# CITY OF ALBUQUERQUE

**RE: Sawmill Market  
Drainage Master Plan  
Engineer's Stamp Date: No Stamp  
Hydrology File: J13D017A**

Based upon the information provided in your submittal received 04/02/2018, the Drainage Master Plan **is not** approved for Building Permit and SO-19 Permit. The following comments need to be addressed for approval of the above referenced project:

NORTH  
A1  
PROPOSED DRAINAGE PLAN  
1"=20'-0"

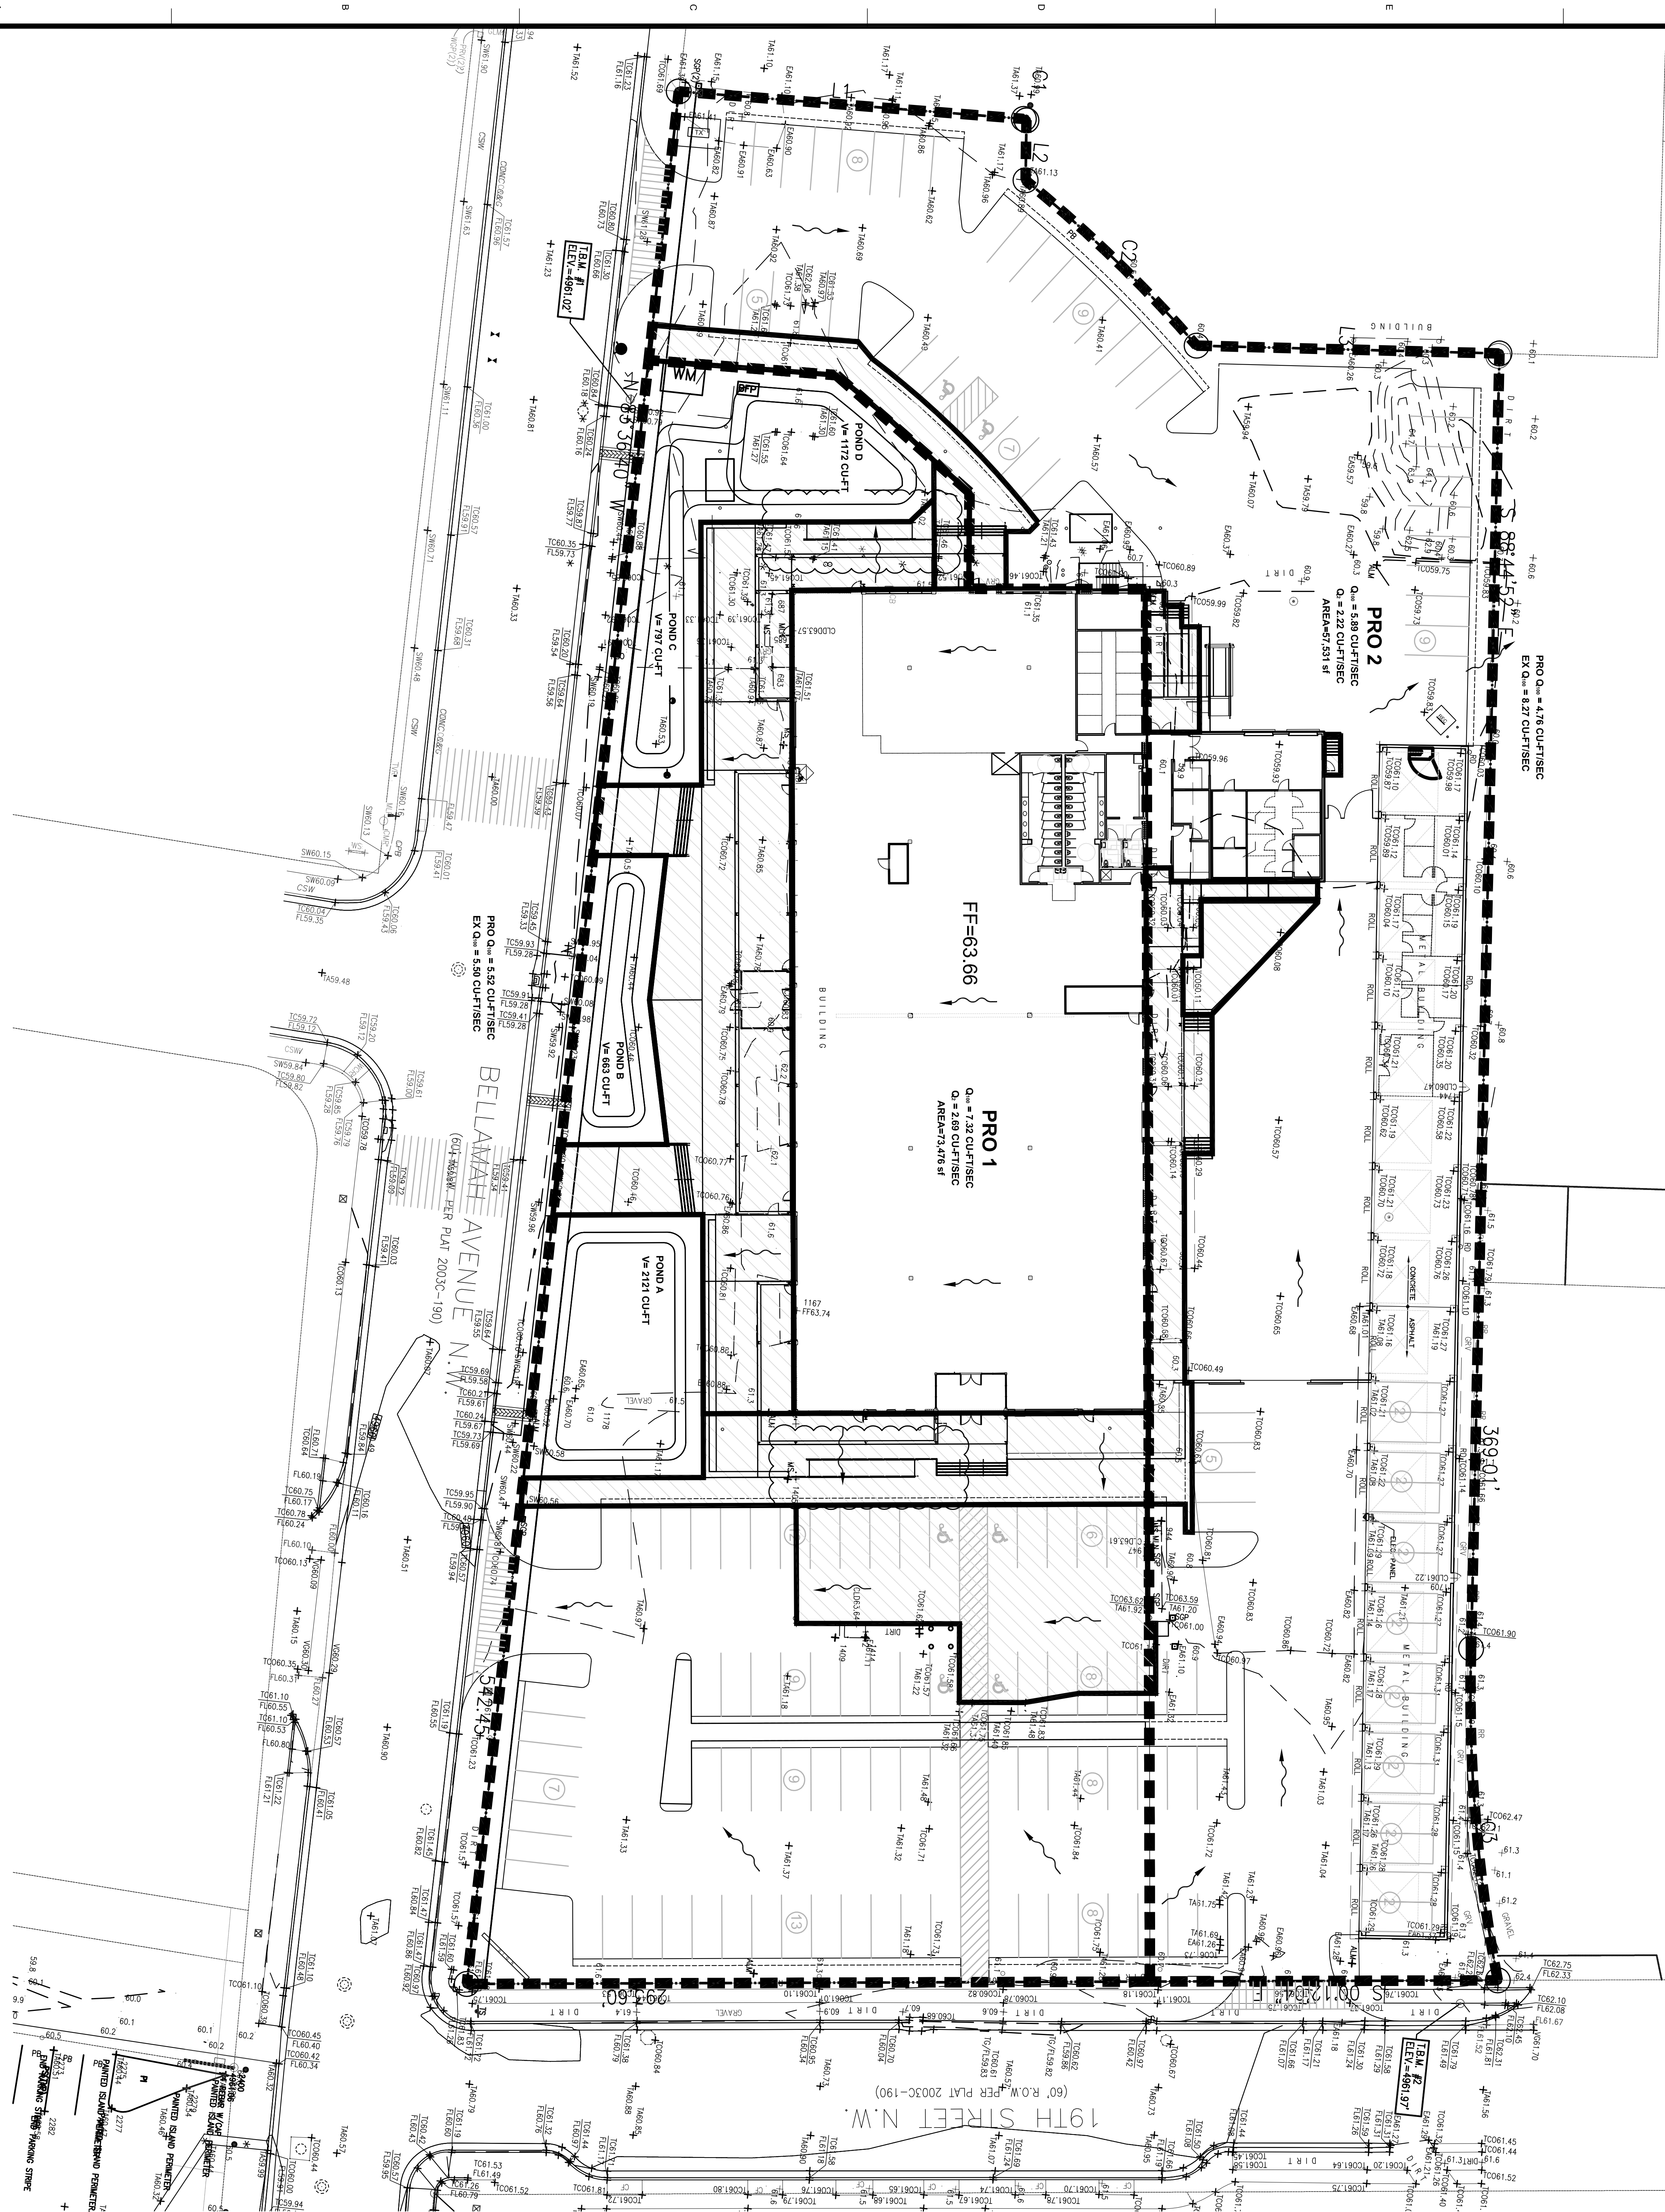
7. Sheet CD1 & CD2. Please correct the drainage calculations to reflect the allowable discharge for the impervious is 0.1 cfs/ac. The allowable discharge is  $0.1 * 0.596 = 0.06$  cfs.
8. Sheet CD2. Please show the pond volume calculations with both the water surface elevation (100 yr – 6 hr) and the discharge rate.
9. Sheet CD2. Please show how each pond is to restrict the discharge for a total of 0.06 cfs.
10. Sheet CD2. Please show the first flush volume in each pond.
11. Sheet CD2. Please reference City of Albuquerque standard detail No. 2236 – Sidewalk Culvert with Steel Plate Top at the sidewalk culvert.
12. Grading Plan. Please show the flowline elevations of the sidewalk culverts.
